EAGLE MOUNTAIN CITY
City Council Staff Report

SEPTEMBER 1, 2015

Project: Questar Salt Lake Mountain Center
Applicant: Questar/EDA Architects
Request: Site Plan Approval
Type of Action: Action Item

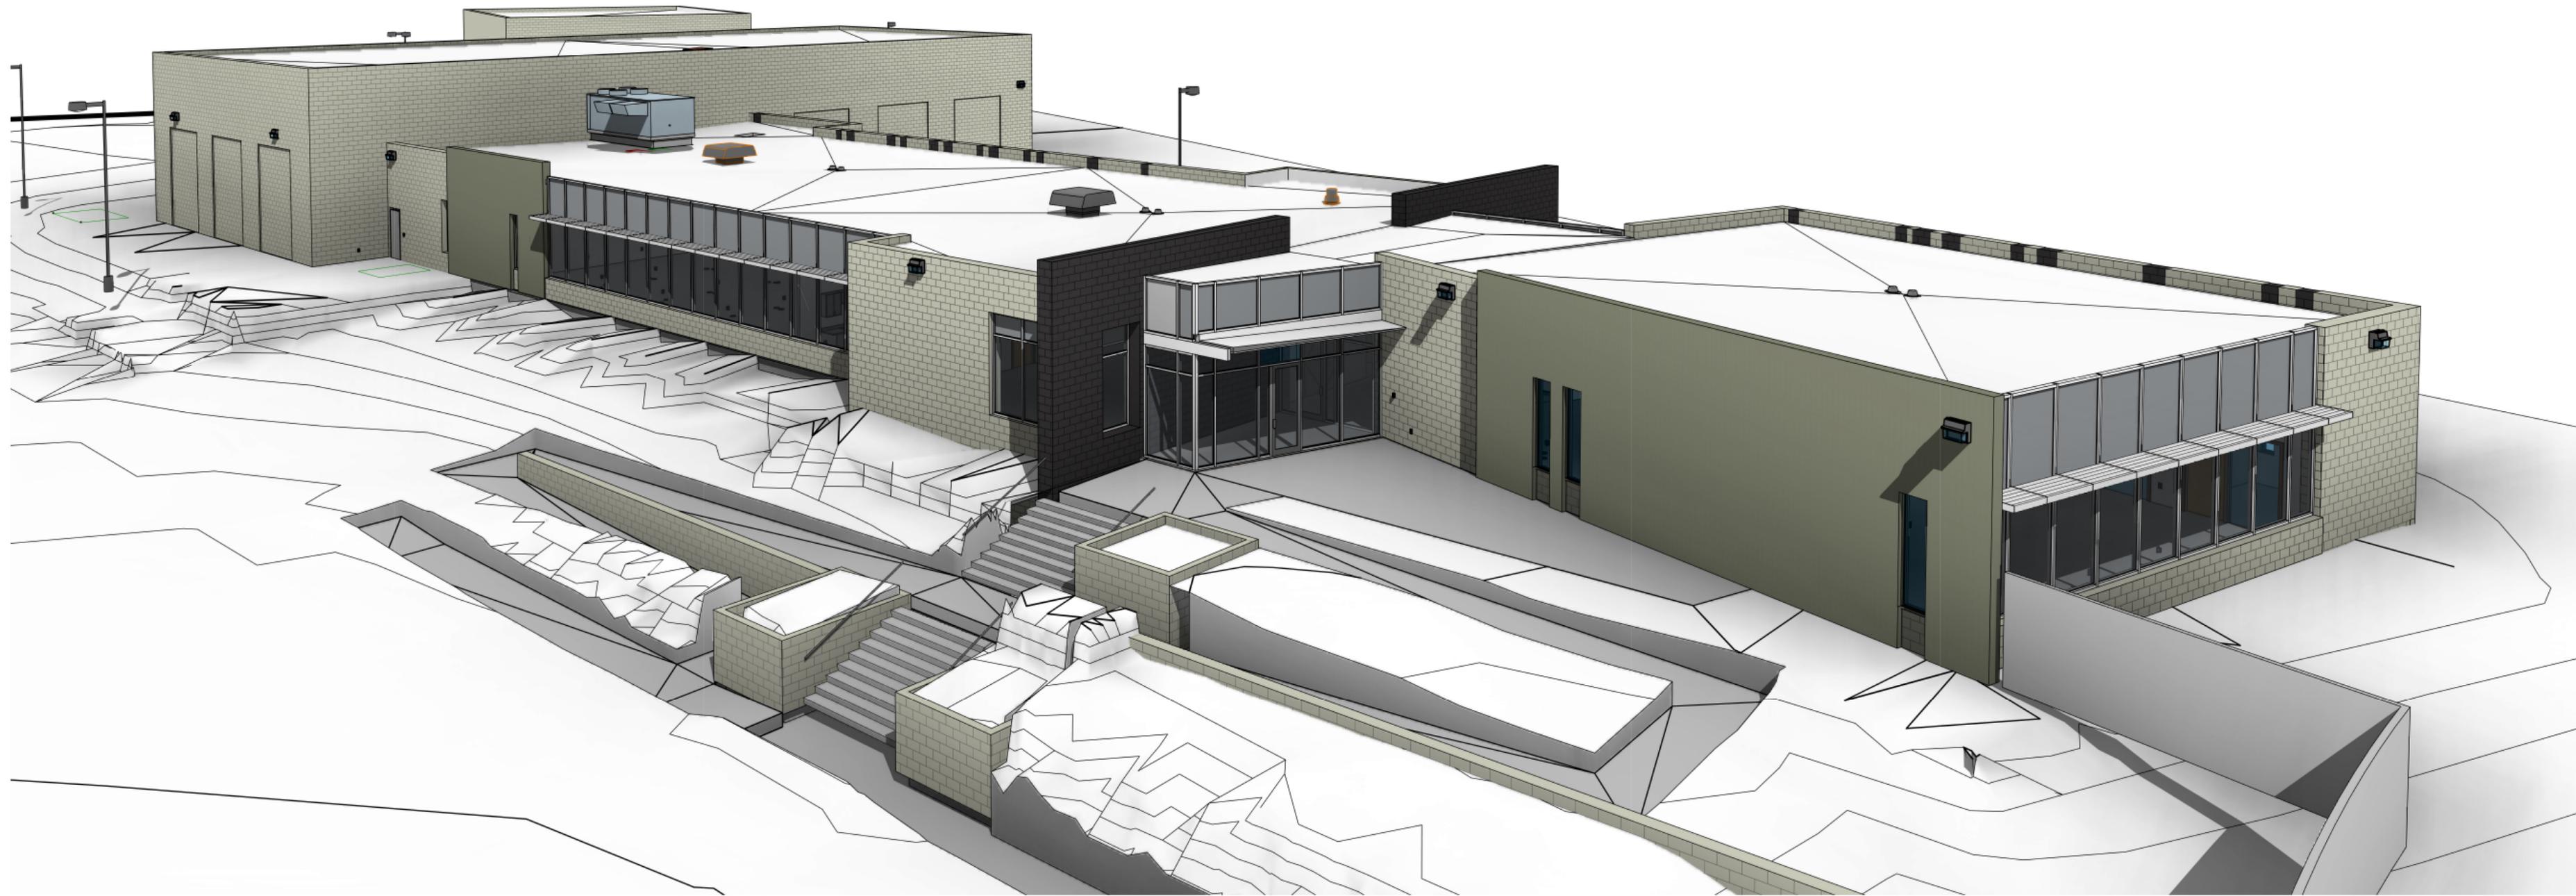
The submitted lighting plan complies with the City's requirements with the exception of the pole height. The applicant is proposing 30-foot high light posts. The following Code section applies to this issue:

A. Parking Lot Standards. Parking lot lighting poles shall be sized in such a manner that the top of any fixture does not exceed 17 feet above adjacent grade. Parking area lights are encouraged to be greater in number, lower in height and lower in light level, as opposed to fewer in number, higher in height and higher in light level. Low pressure sodium (LPS) lamps are encouraged.

1. That an updated landscape plan is submitted and approved by City Staff including turf in the park strips.
2. That the lighting plan be revised so that the parking lot lighting fixtures not exceed 17 feet in height.

L-L101

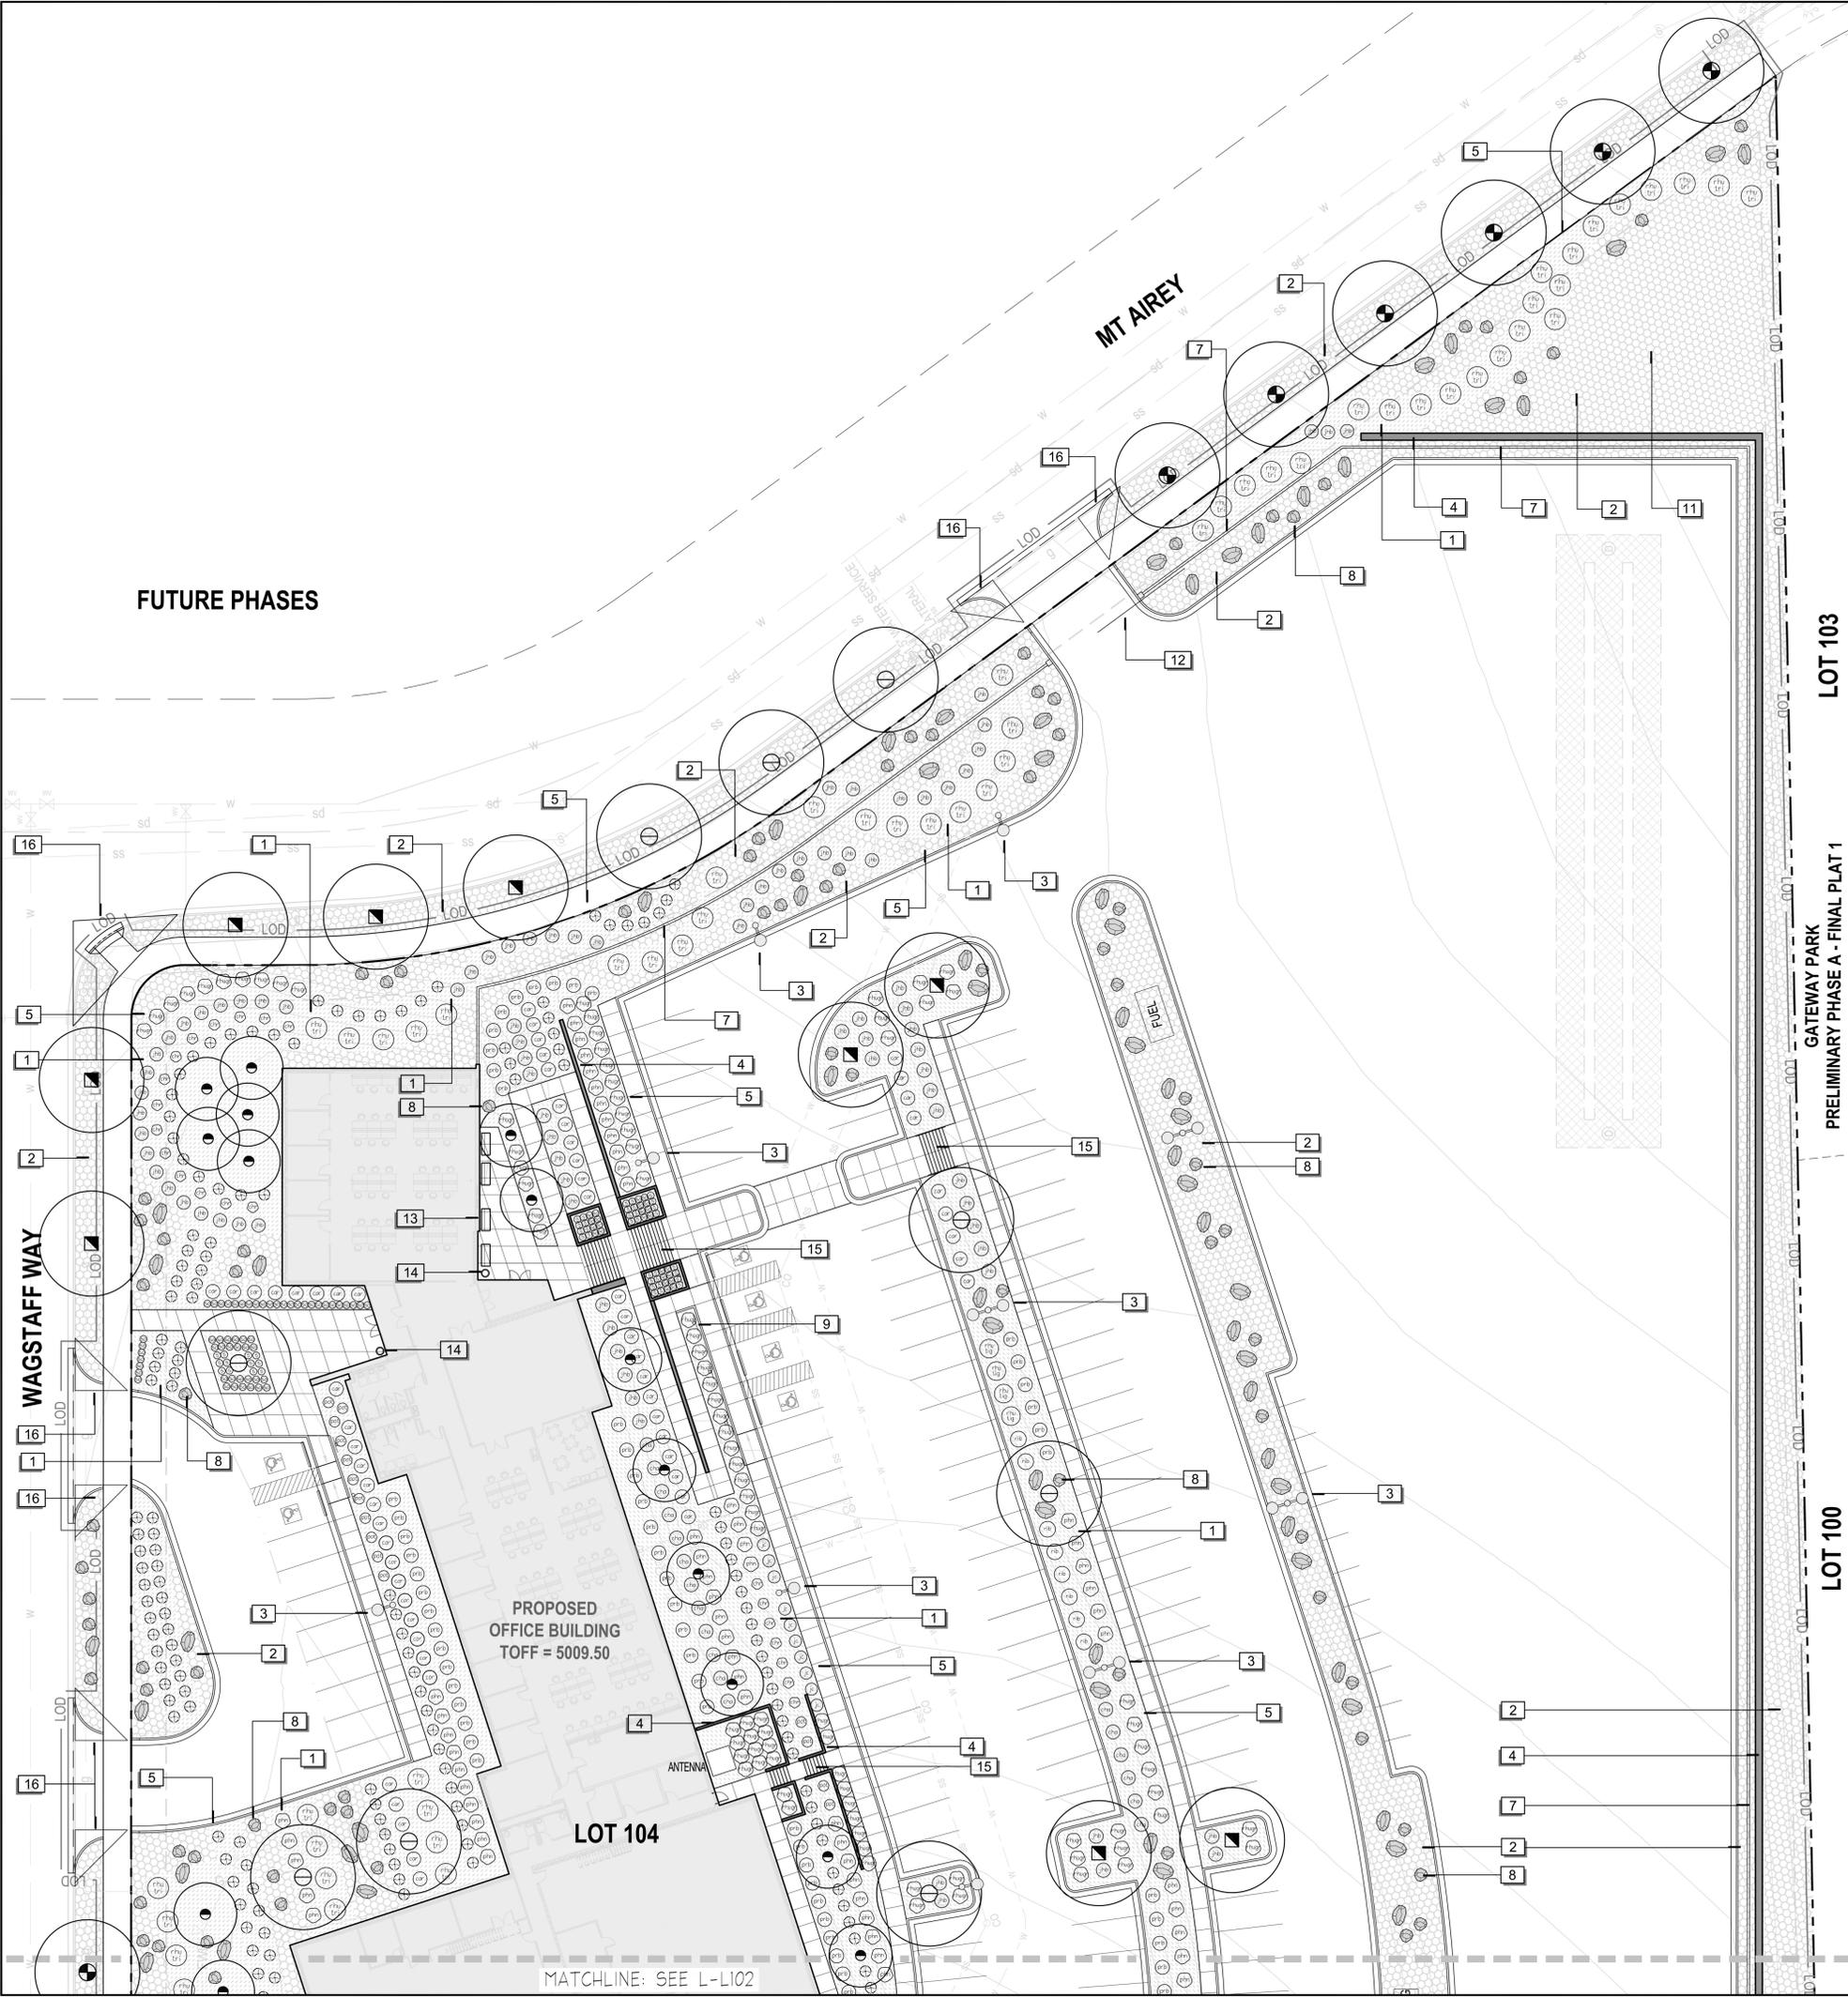
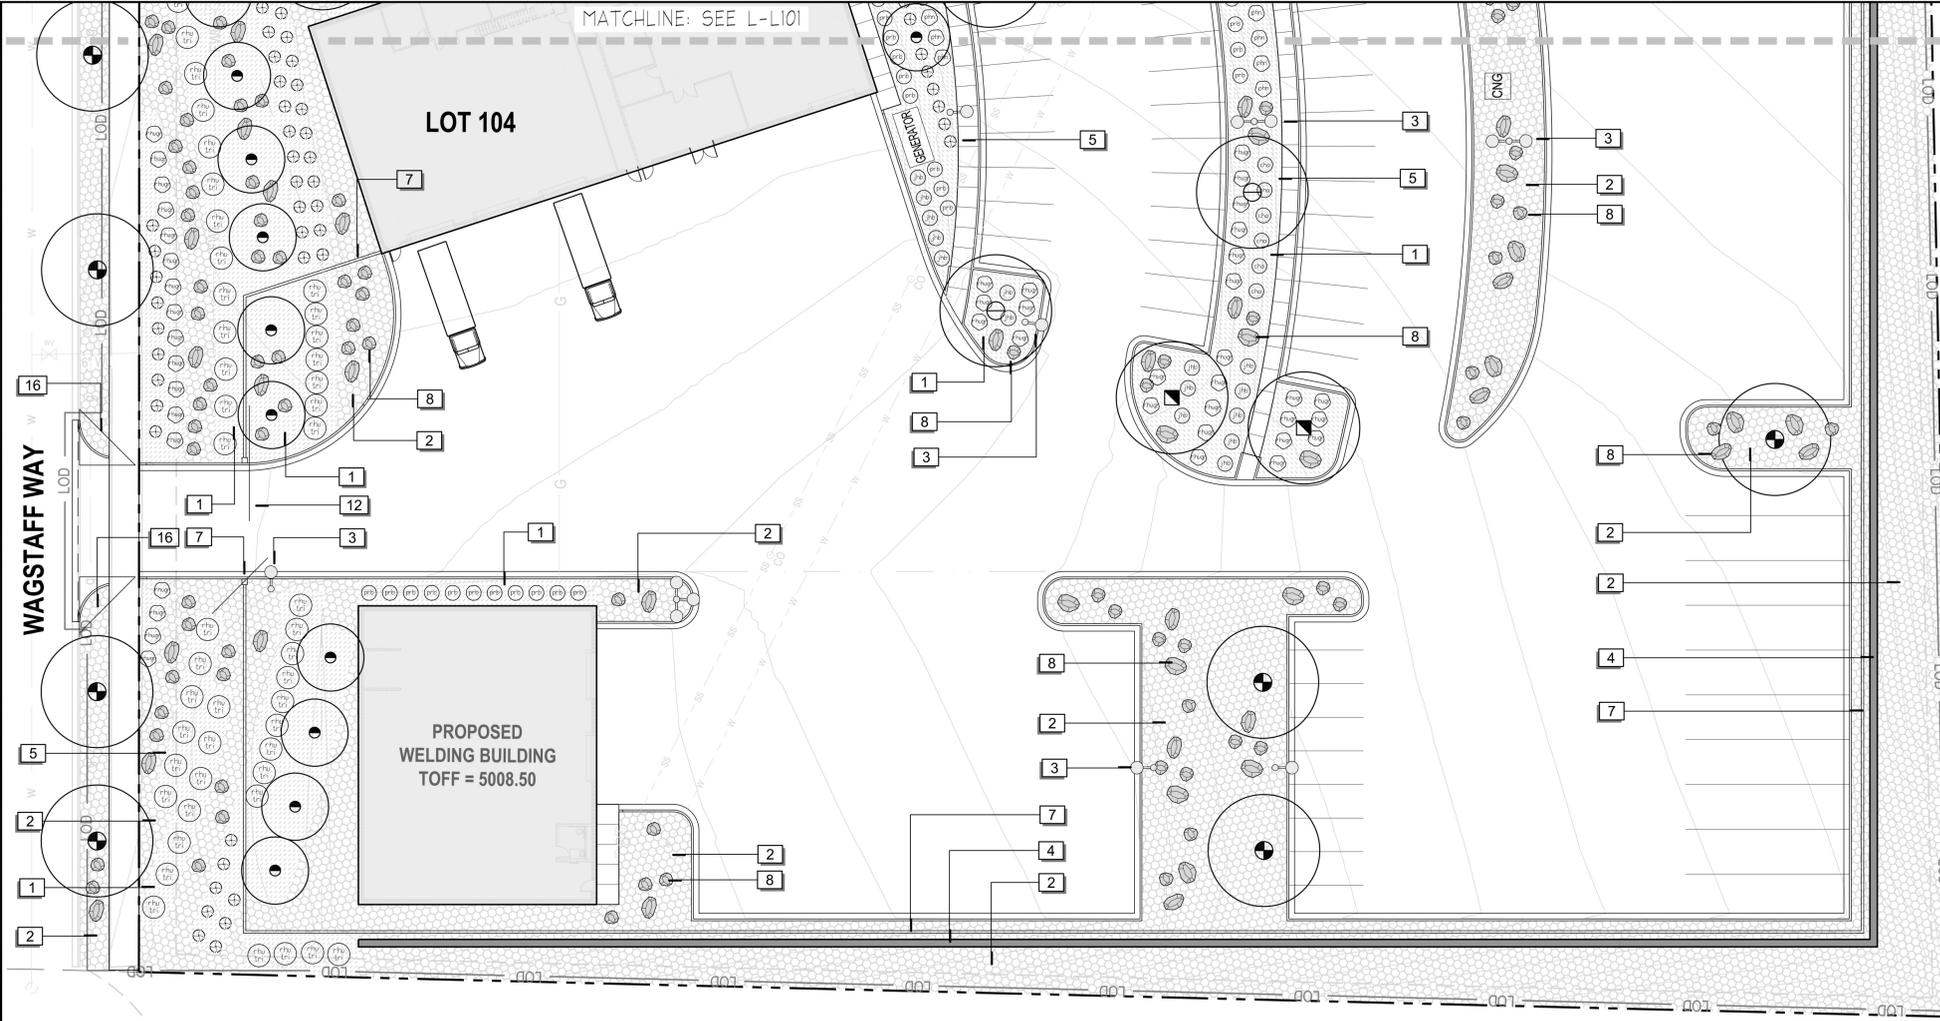
The landscape plan the applicant has submitted does not fully comply with the Code in some areas, but exceeds the Code in other areas. City Code requires that a site this size install at least 50% of the landscaping in turf (Chapter 17.60). The plan submitted consists completely of xeriscape. The Planning Commission recommends that the Park Strip be landscaped with grass and trees (consistent with Ace Rents to the south) while the remainder of the site should be approved as submitted. The submitted plan includes more than four times the number of trees that are required, and exceeds the requirement for drought tolerant shrubs.
